IMCA Safety Flash 06/08

I Sikorsky S76A+ and S76A++ Helicopters

SERVICE BULLETIN

Subject: Installation of a sealed Power Turbine (PT) overspeed tachometer box.
Incorporation of modification TU 330.

ANNEXE 1 / APPENDIX 1

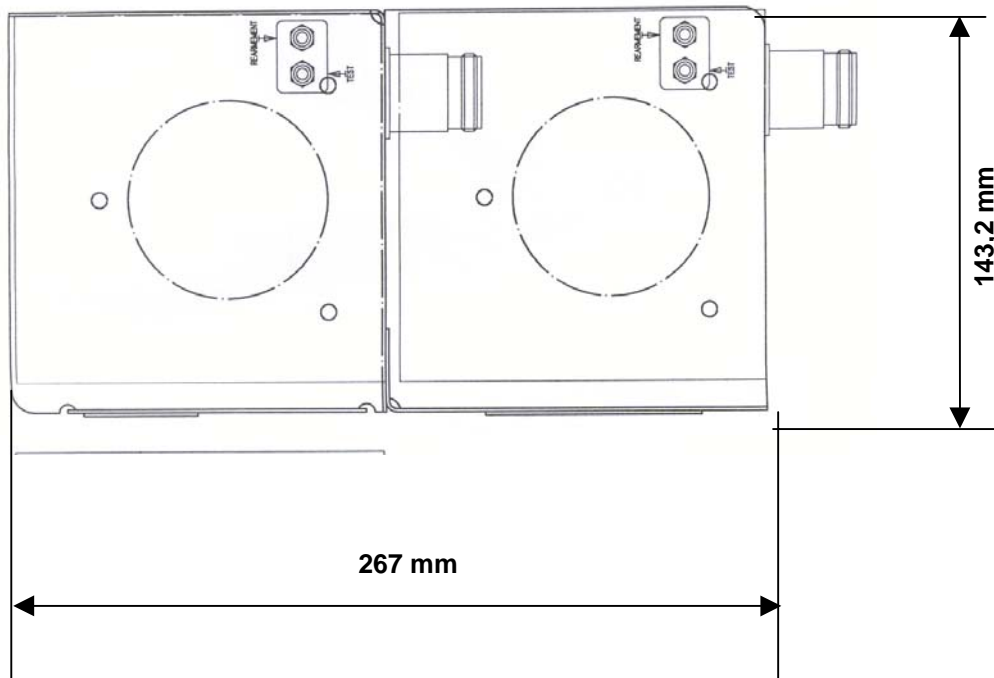
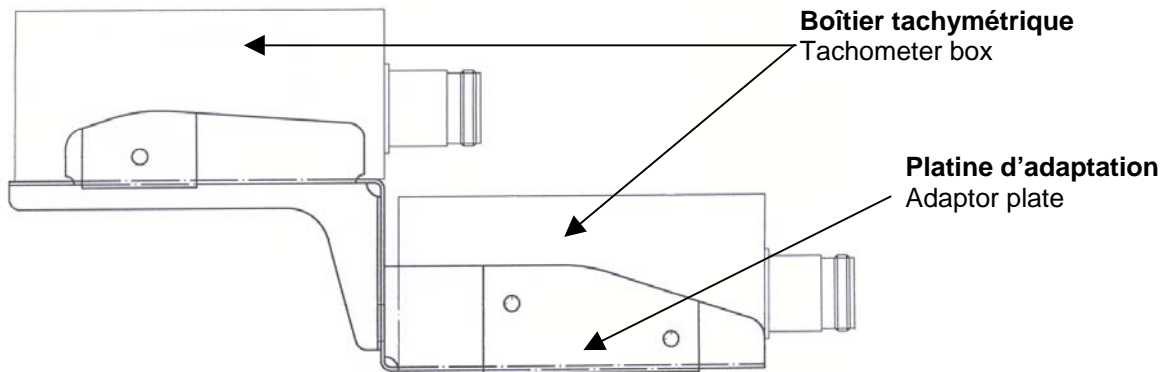
This modification consists of introducing the post TU 330 tachometer box as an option in order to allow the replacement of pre TU 330 boxes that show traces of corrosion or that are used in humidity-saturated atmospheres.

This replacement requires a new adaptor plate that is compatible with all boxes manufactured by TURBOMECA.
